Romo Fashion Today Ltd. (Extension 2)

Vannera Road, Mouchak, Kaliakoir, Gazipur

30th January 2019

**Columns appeared to be stressed in excess
of normal design limit**

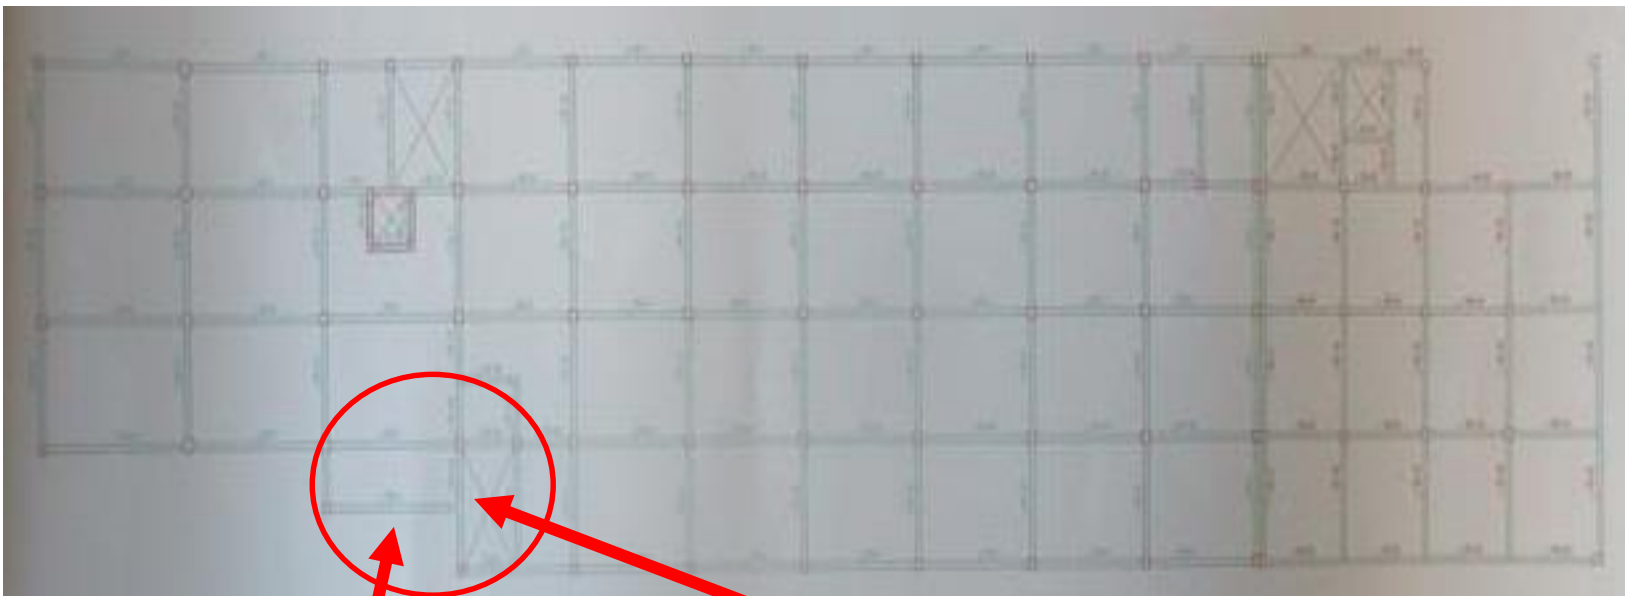
Cursory calculation indicates that highlighted columns appear to be stressed above normal design limit.

Column layout plan

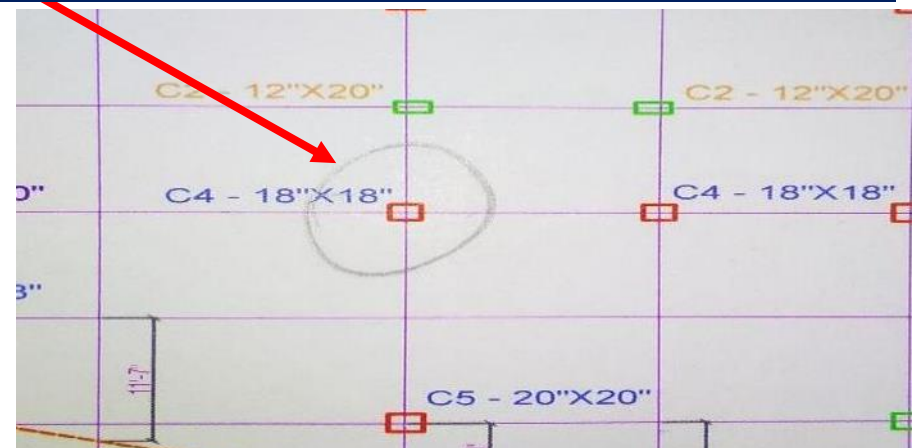
C4 column dimension was measured to 18"x18" (450mm x 450mm) on site which was mentioned in column layout plan. But it was shown 21"x21" (525mm x 525mm) in column schedule.

Undocumented telecommunication tower on roof of Main Building

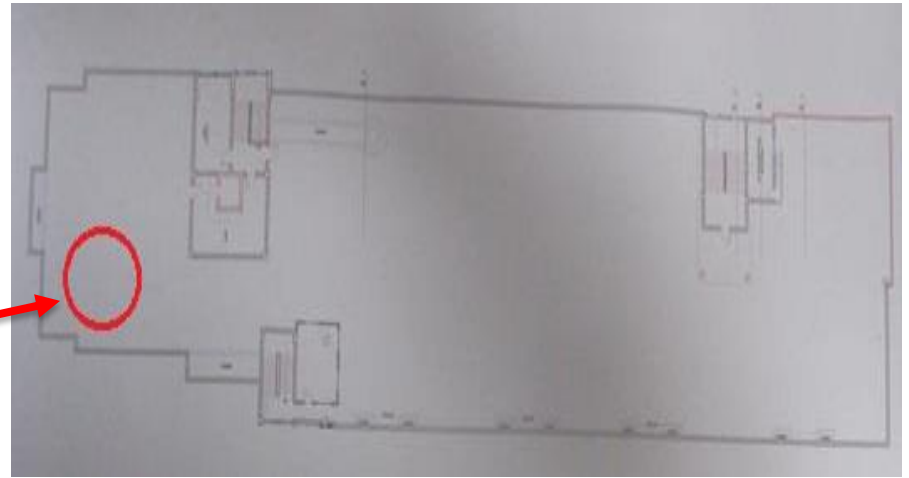
Undocumented telecommunication tower was observed on the roof.

A telecommunication tower observed on the roof which was not shown in as built drawing
